SERVICE LETTER

No. 445

Piper Aircraft Corporation

SUBJECT: Installation of Nose Gear Drag Link Clevis Reinforcement Bracket

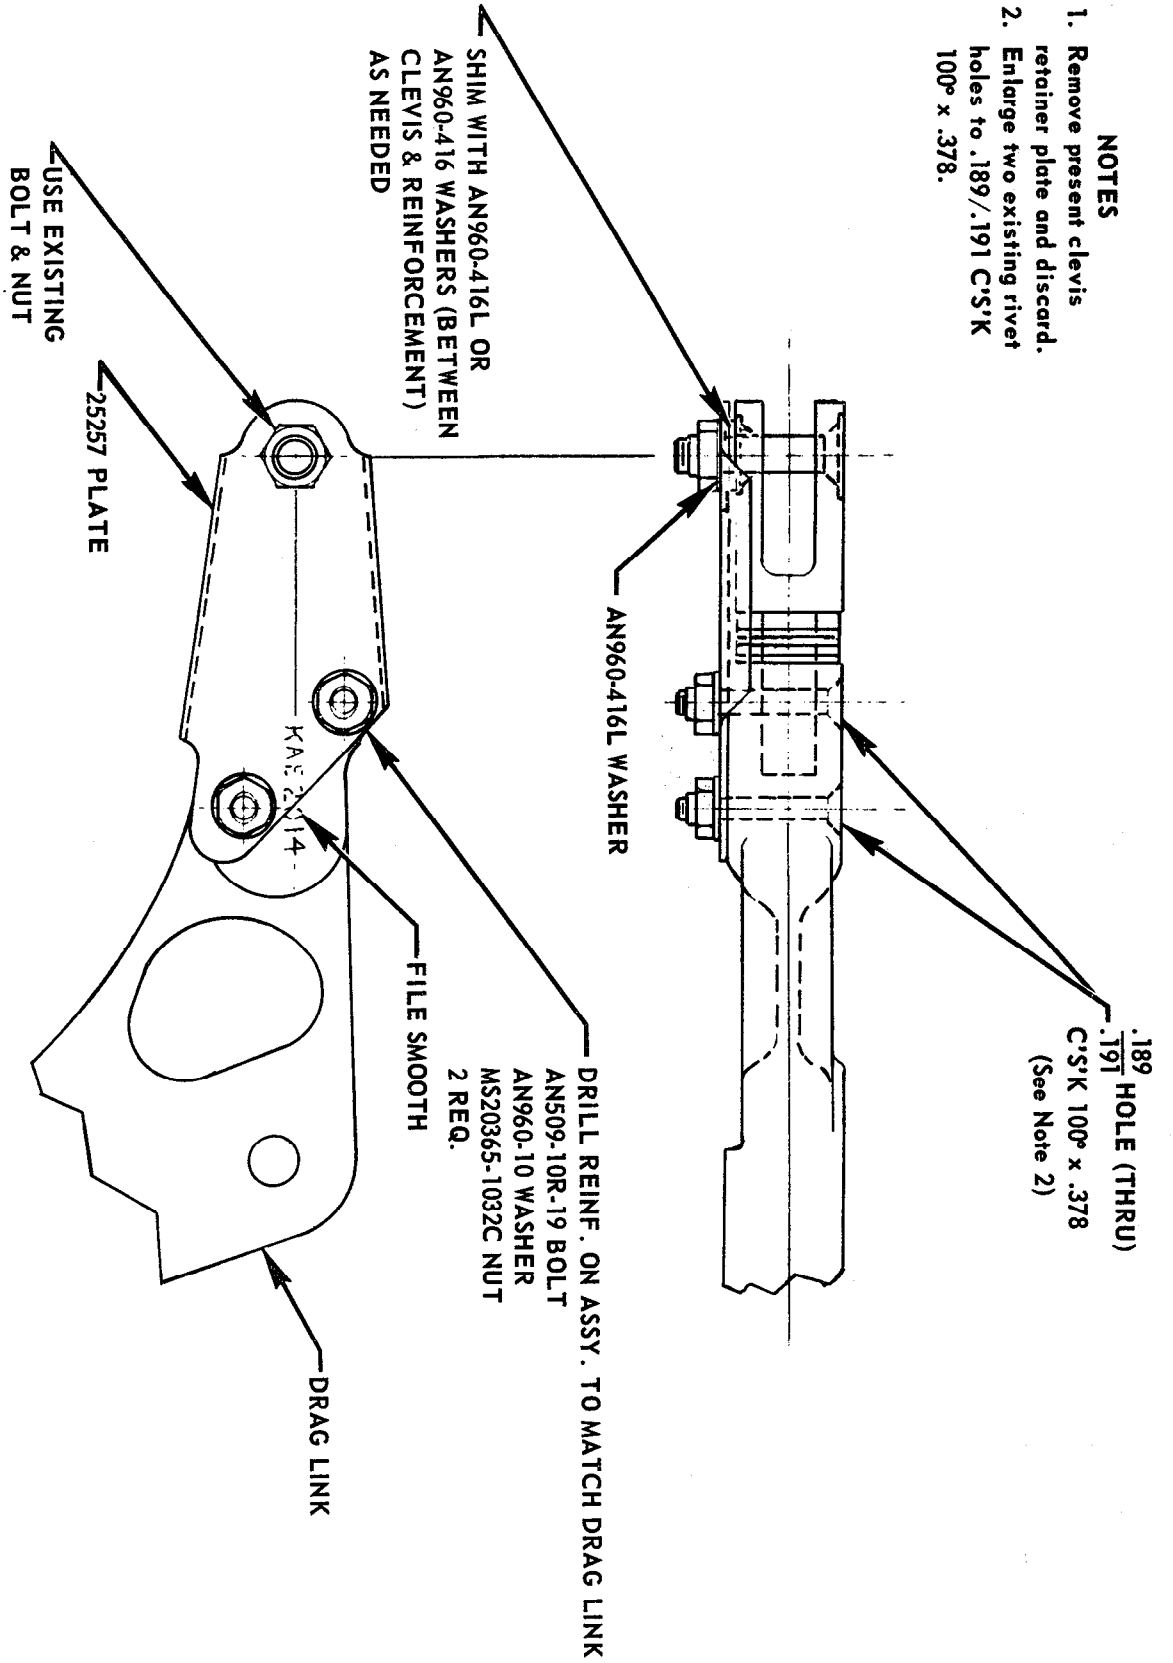
This Service Letter is to advise that Kit No. 756 911 consisting of a nose gear drag link clevis reinforcement bracket and necessary hardware is available for installation on the aircraft indicated by the above serial numbers.

It is requested that the reinforcement bracket, which is applicable to clevises, part numbers 20859-03 (HT), 20859-02, or 20859-00, be installed to derive the benefit of the additional support. See sketch on the reverse side of this Service Letter.

1. Remove present clevis retainer plate and discard.
2. Enlarge two existing rivet holes to .189/.191 C'S'K 100° x .378.
